142652/FO/2025: Chorlton Shopping Centre Redevelopment - Arboricultural Technical Note

Planning Context:

Figure 1a: Locations of the two TPO trees located offsite.

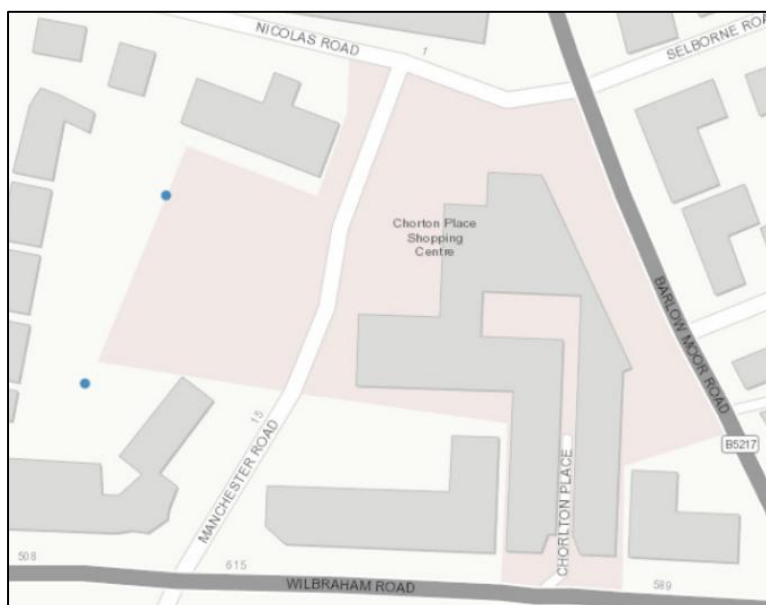
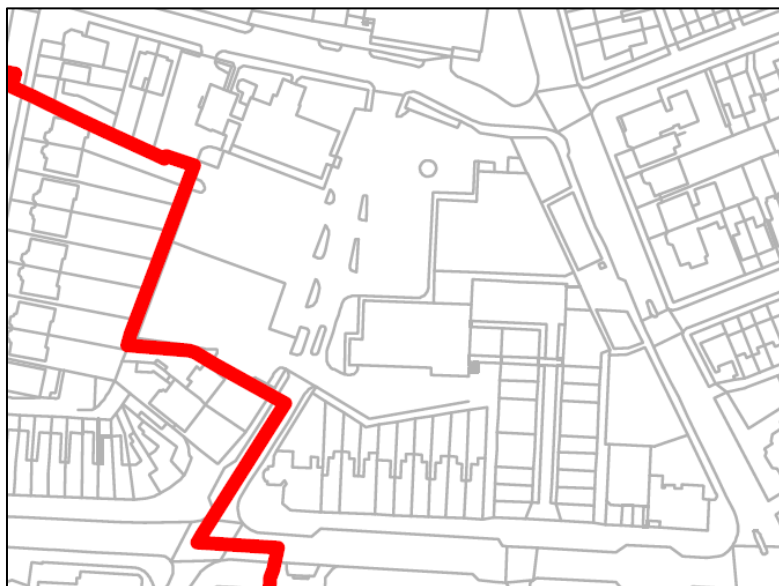
1. *"The submitted arboricultural assessments fail to protect trees subject to Tree Preservation Orders within the adjacent Edge Lane/Willbraham Road Conservation Area. (Trees specifically referred to in application documents are G2, G1, T3, T4, and T5).*

The submitted AIA report (Ref: 16173_R02b) detailed that there were no Tree Preservation Orders (TPO's) or Conservation Area (CA) coverage directly inside the red line application boundary and that remains accurate.

As per Figures 1a and 1b below, sourced from the MCC website, the 2no. TPO trees are located beyond the application redline boundary (off-site) and 'Wilbraham Road/ Edge Lane Conservation Area' boundary runs along the existing boundary of the application site with the residential properties to the immediate west.

- Northerly dot: Sycamore, TPO ref: The Manchester City Council (14 Oswald Road, Chorlton) TPO 2003, PGSM9JBC03O01.

This Sycamore tree is identified in the submitted AIA and on the Tree Retention & Removal Plan (TRRP) as being located within tree group reference G2. This Sycamore is located outside the application boundary but is within the Conservation Area.

As set out in the submitted AIA and shown on the TRRP, it is proposed to undertake crown lift pruning by up to approximately 2.5m within the eastern canopy extent of G2 (excluding the cluster of 3no. cypress and 2no. silver birch to be removed which are not TPO'd and are outside of the CA), to provide sufficient construction clearance for the proposed car parking surfacing works.

- Southerly dot: Lime, TPO ref: City of Manchester (Oswald Road/Vincent Avenue, Chorlton) Area TPO 1995, PGQYIWBC03O01.

This tree, which is also within the CA is identified in the submitted AIA and shown on the TRRP as tree reference T3. No works including pruning are proposed to this tree.

- The CA boundary includes most of the trees in G2, but the trees in G2 proposed for removal in the submitted AIA (2no. Silver Birch trees and 3no. Cypress trees) are not within this CA extent.

The image shows the proposed 5no. trees in G2, identified for removal. At the outset it is important to note that these trees are located outside of the defined conservation area (inward of the boundary which runs along the Oswald Road property boundary) and are not subject to TPOs.

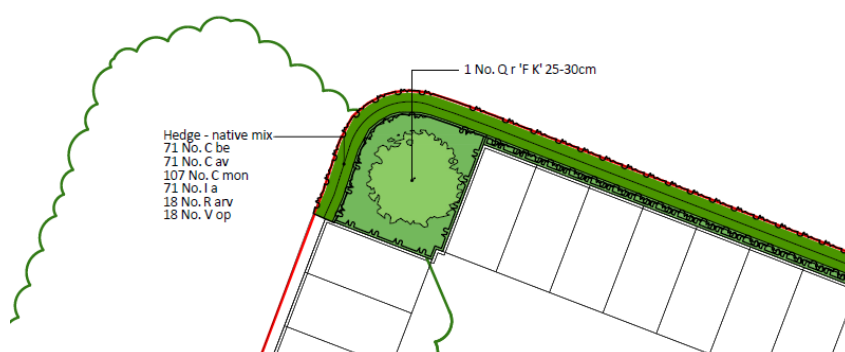
6. *In the northwest corner the boundary is ambiguous. The proposal is to remove tall trees within the health centre property to accommodate residents' car parking for the development. The tall evergreen trees are valuable as screening between the health centre, the development site and Oswald Road properties.*

The area of G2 which is proposed for removal contains the loss of 2no. Birch trees and 3no. Cypress trees, as shown below which are off-site on a square raised planting segment bound by fencing and hard surfacing.

In terms of the trees proposed to be removed, these are identified within the submitted AIA (Appendix 4) as being within BS5837:2012 Category B2 – *'trees of moderate quality and of mainly landscape value'*. Consequently, the trees are not of the highest quality and offer limited arboricultural amenity merits. Therefore, it is proposed to replace the trees, as per the submitted soft landscape plan (Randall Thorp – extract below with 1no. Oak tree and a new hedge (native mix). This is considered to provide a betterment long-term and provide the applicant with the ability to effectively manage the area and secure biodiversity enhancements relative to the current baseline condition.

Finally, the loss of these trees within G2 will not cause major screening loss effects due to replacement tree planting and the limited angles of views which are possible through this channel to the residential dwellings on Oswald Road to the west.

Therefore, the applicant considers that the removal of non-protected trees of 'moderate quality' (as per the relevant BS5837:2012 standard classification) is fully justified with appropriate localised compensation.
